Ashton Village Center Sect...

Subject Ashton Village Center Sector Plan: Comments on Working Draft

WORKING DRAFT – JULY 2020

Map 8. Proposed Zoning

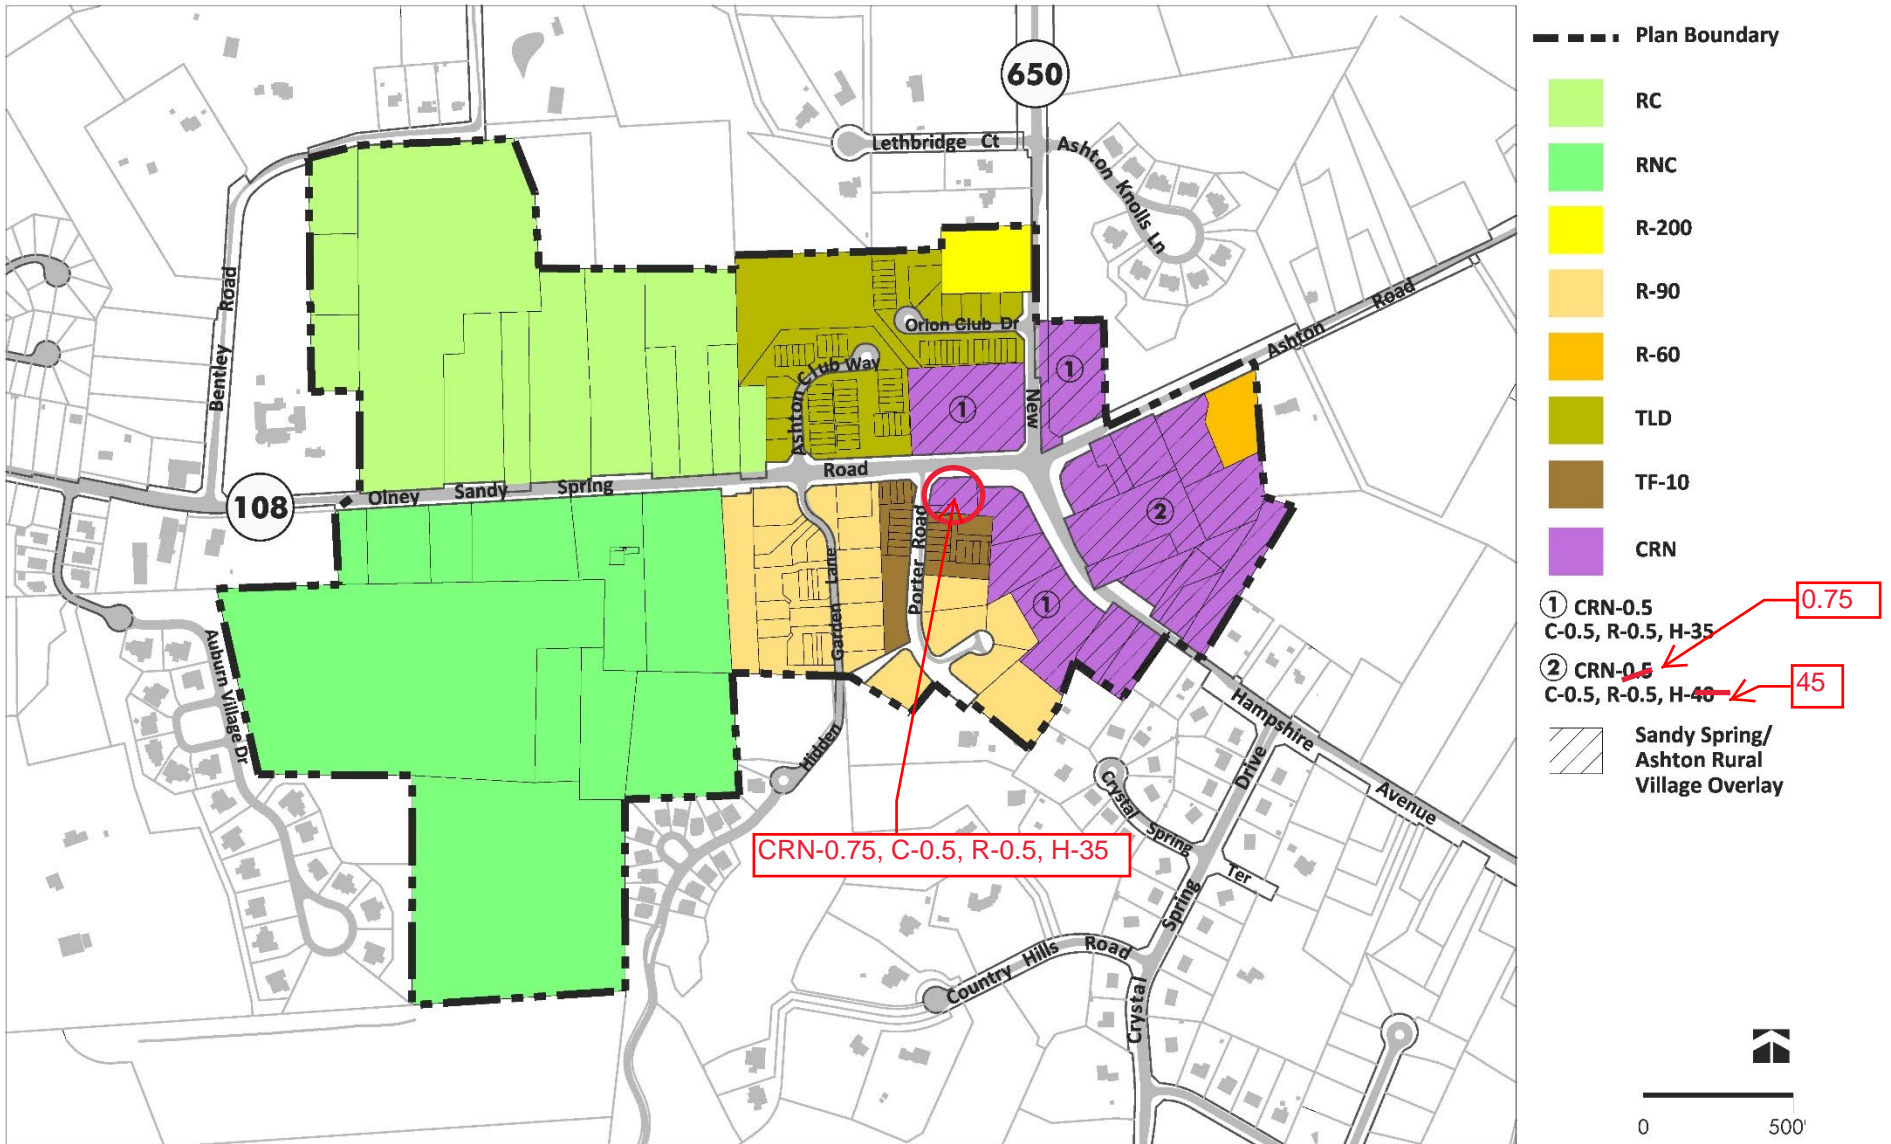
, with the exception of the mixed uses portion of the Ashton Market site, which should be rezoned to CRN-0.75, C-0.5, R-0.5, H-35 to conform to the Village Core CRN zoning while retaining its current density.

This language is suggested for consistency with page 53.

0.75

45

Map 12. Recommended Open Spaces

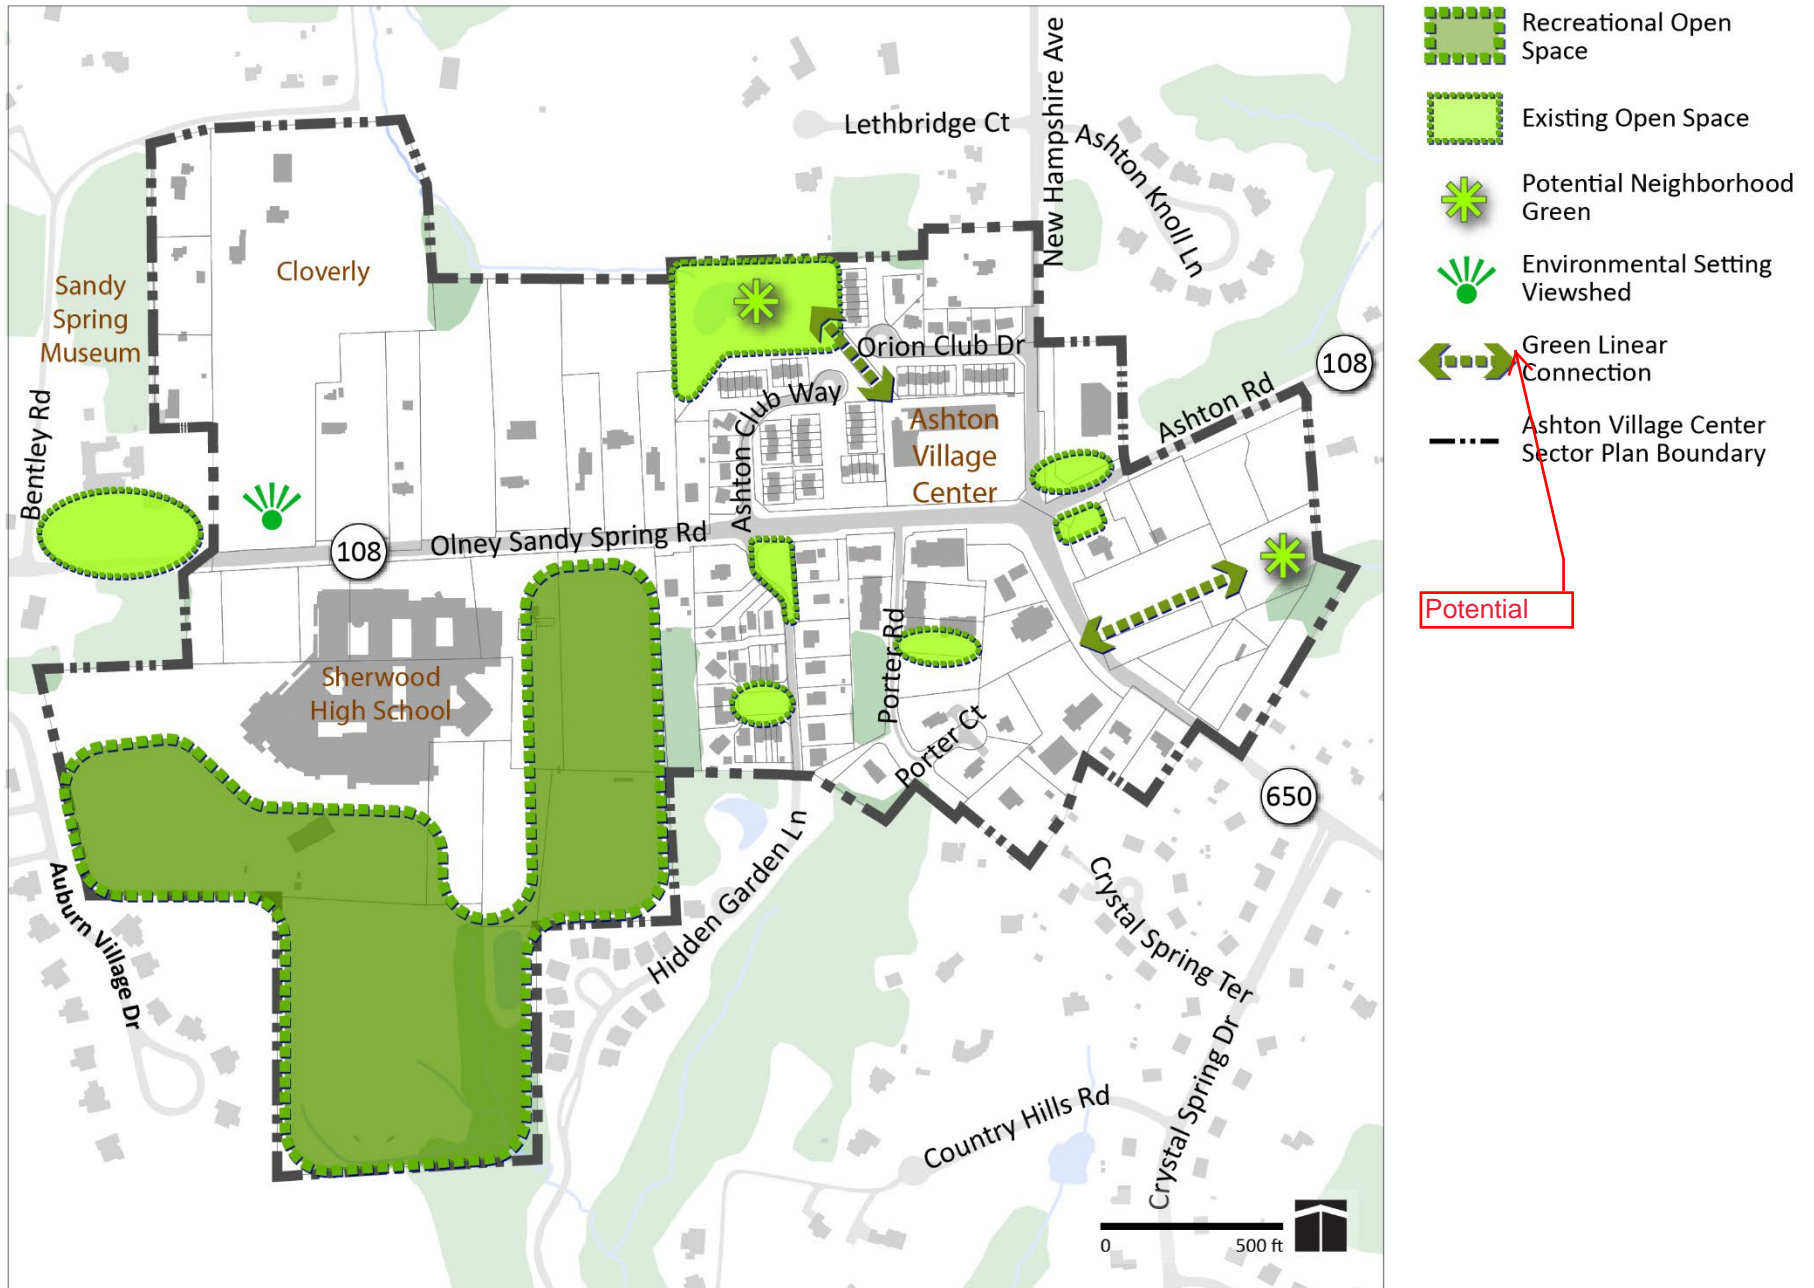
Nichols is willing to entertain the possibility of a village green that will be open to the general public, but wishes to reserve the flexibility to have additional, smaller open spaces that are open only to residents of the new development.

that are intended to be open to the general public

This green may be in private or public ownership, to be determined at the time of development.

that is intended to be open to the general public
